**Certificate of Final Plan Approval**

<b>Plan Number:</b> 2025022048	<b>Property Address:</b> 108 MOUNT VERNON AVE MOUNT VERNON OH 43050	<b>County:</b> KNOX
<b>Date of Approval:</b> 10/25/2025	<b>Type of Project:</b> New Building	<b>Governing Building Code:</b> 2024 OBC
<b>Building / Business Name:</b> MAIN COESSION STAND	<b>Description of the Project:</b> This project consists of the construction of a 1156 Sq ft concession stand and restrooms.	
<b>Property Owner:</b> MT VERNON CITY ENGINEERING  40 PUBLIC SQ MOUNT VERNON OH 43050	<b>Submitter:</b> MKC Architects BAYLEIGH HETRICK 161 4th ST N COLUMBUS OH 43215	<b>Design Professional:</b> MKC ARCHITECTS MATTHEW TEISMANN 161 N 4TH ST Suite 100 COLUMBUS OH 43215
<b>Approved Scope of Project:</b>  General Building Trade Mechanical Electrical	<b>Authorized No. of Inspections:</b>  5 5 5	<b>Use Occupancy Groups:</b> B
		<b>Construction Type:</b> Type III B
		<b>Building Floor Area (s.f.):</b> 0.0

CPA #2025022048 - Full Approval  
BUILDING PLAN APPROVAL (BP)  
Print all materials and retain at the site  
10/27/2025

# Memorial Park - Main Concessions

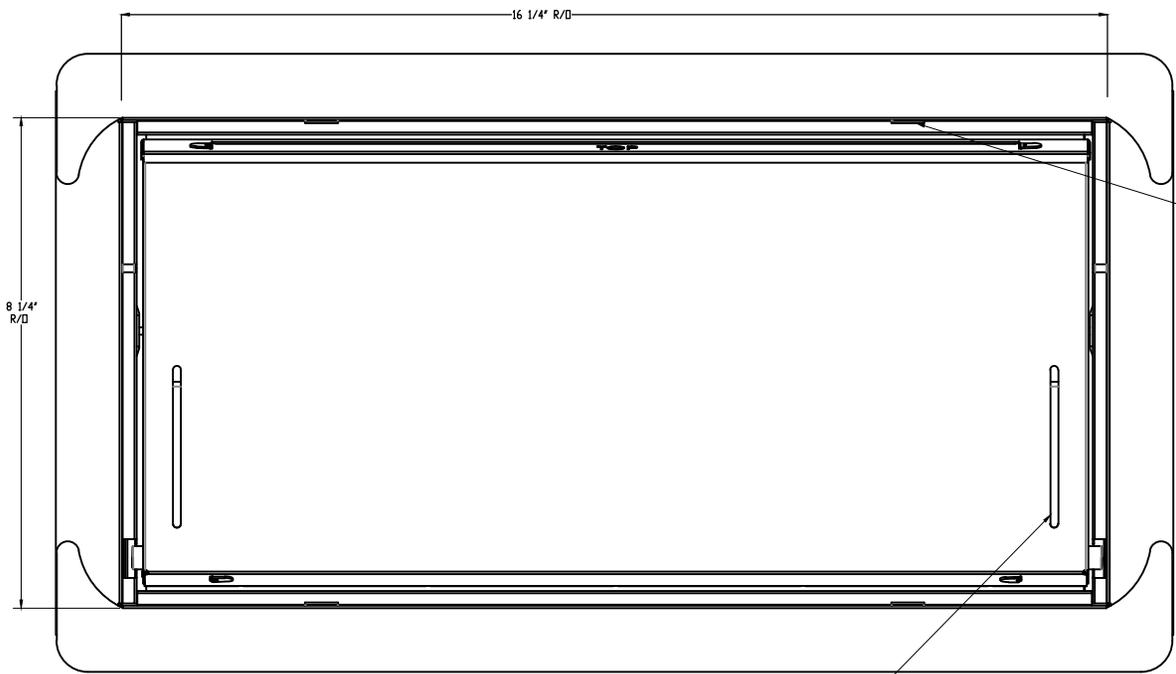
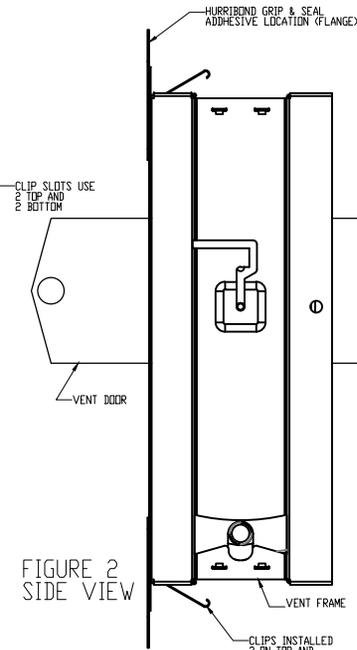
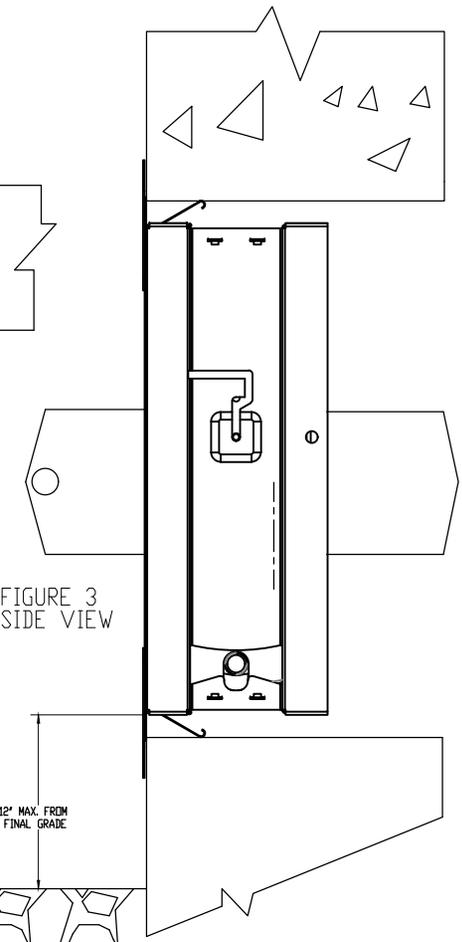
- a. The drawings indicate flood vents. Please provide the criteria for the flood vents (required opening per floor area/room, etc.)

**Response: Please refer to attached Smart Vent Flood Louver cut sheets and flood opening data as provided and approved by the City of Mt. Vernon engineers.**

**1** SECTION (FRONT) VIEW  
 R22 [U-0,28] INSULATION WITH 7.75" [197mm] CONCRETE CORE

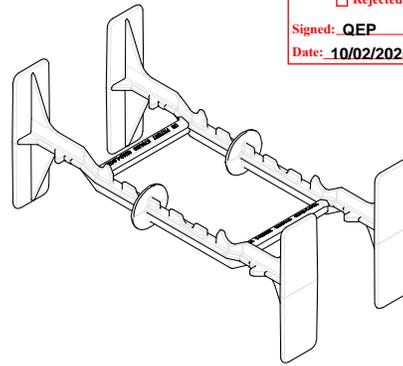
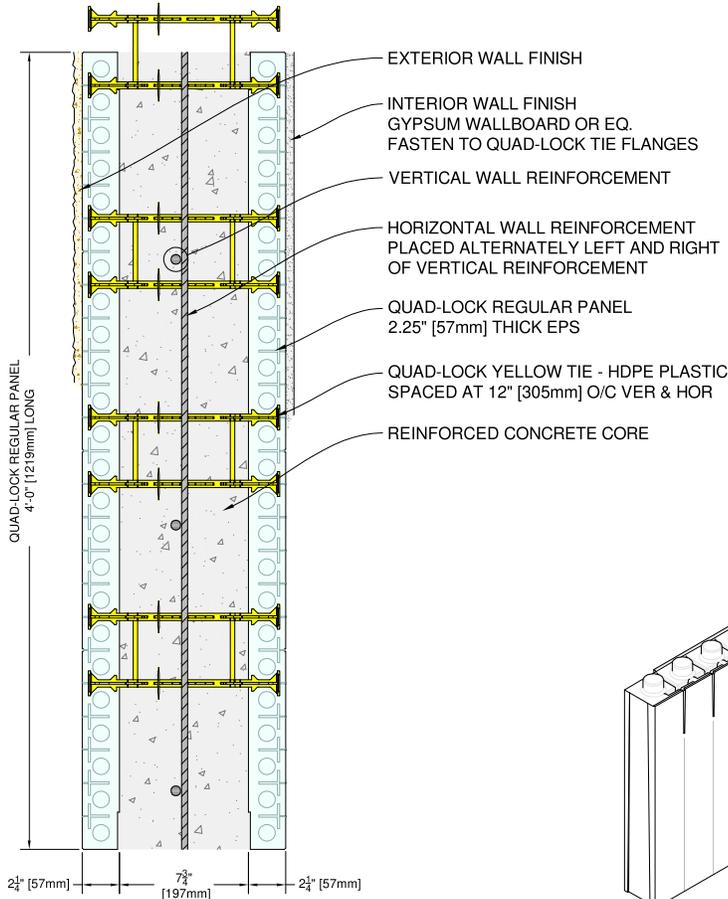
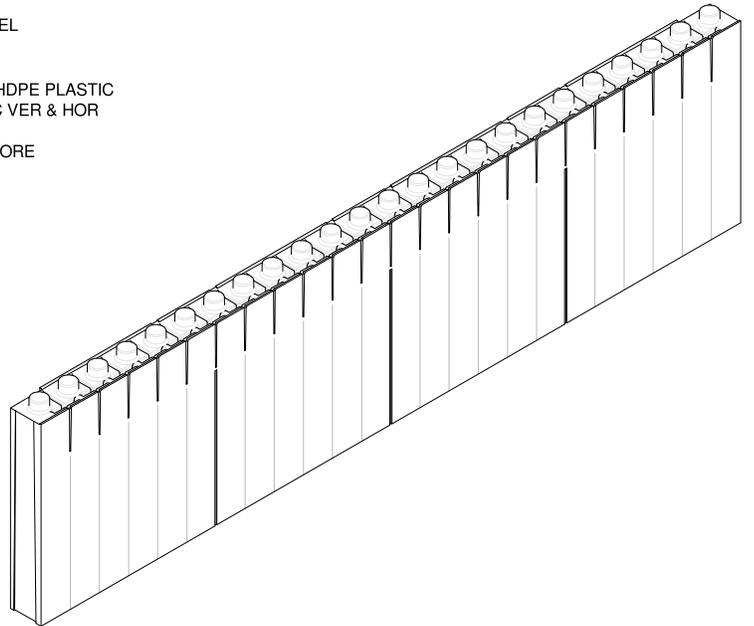
f. Insulation is shown but not called out. Please clarify.

**Response: Please find attached the ICF system specification sheet, with the insulation value corresponding to this system thickness highlighted. Refer to wall sections and rake detail for provided attic insulation (A1 & C4/A300). R-values for the attic insulation and wall insulation are noted as R-49 and R-11.4 continuous minimum for those elements respectively in the revised keynotes on the A300 sheet, in accordance with Ohio Energy Code table C402.1.3.**

**C5 LEVEL 01 REFLECTED CEILING PLAN**  
A101 SCALE: 1/4" = 1'-0"

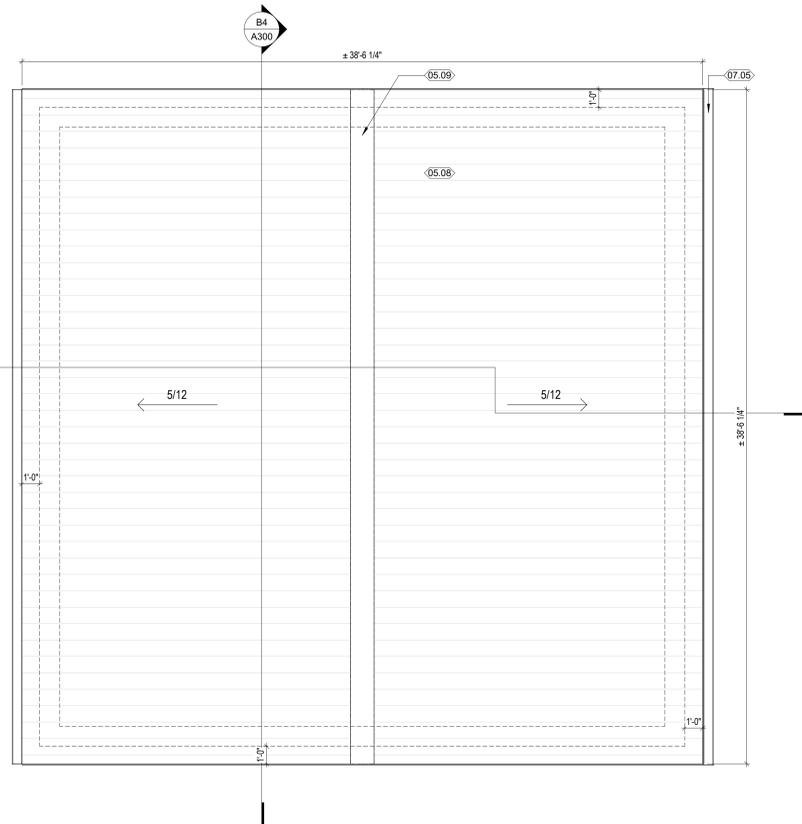
- c. As per 2024 OBC 1209.2, please provide direction on the required attic access.

**Response: Attic access panels have been provided. Please refer to the roof framing plan (C3/S101) and the reflected ceiling plan (C5/A101) for locations and keynoted spec.**

**1 MECHANICAL FLOOR PLAN**  
SCALE: 1/4" = 1'-0"

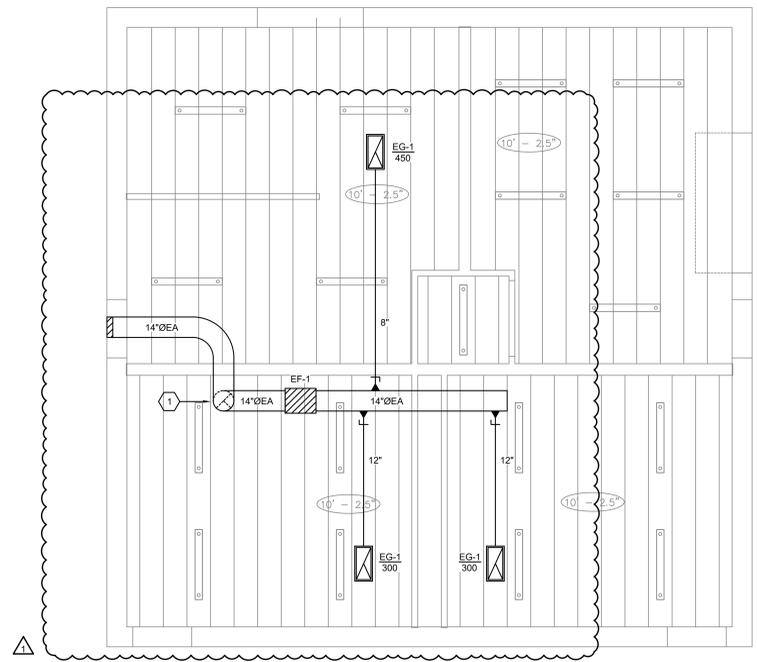
- d. As per OMC 306.5.1, please provide direction on the required platform around the roof mounted exhaust fan.

**Response: The exhaust will be ducted out to a dedicated gable louver meeting required CFM.**

1. ROUTE EXHAUST DUCT UP INTO ATTIC AND TERMINATE WITH 14"x34" GABLE LOUVER. REFER TO ARCH. ELEVATION FOR MORE INFORMATION. LEAVE OPPOSITE GABLE LOUVER OPEN FOR ATTIC VENTILATION. EXHAUST DUCTWORK IN ATTIC TO BE INSULATED WITH 1.5" INSULATION.

3 SINGLE LINE DIAGRAM  
SCALE: NTS

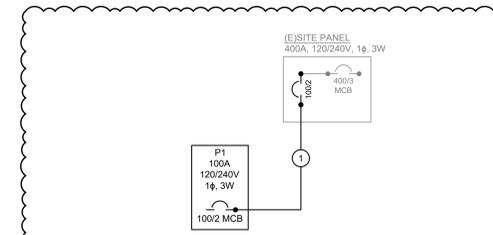
- e. Please provide a one-line diagram.

**Response: Please see revised sheet E100 for one-line diagram.**
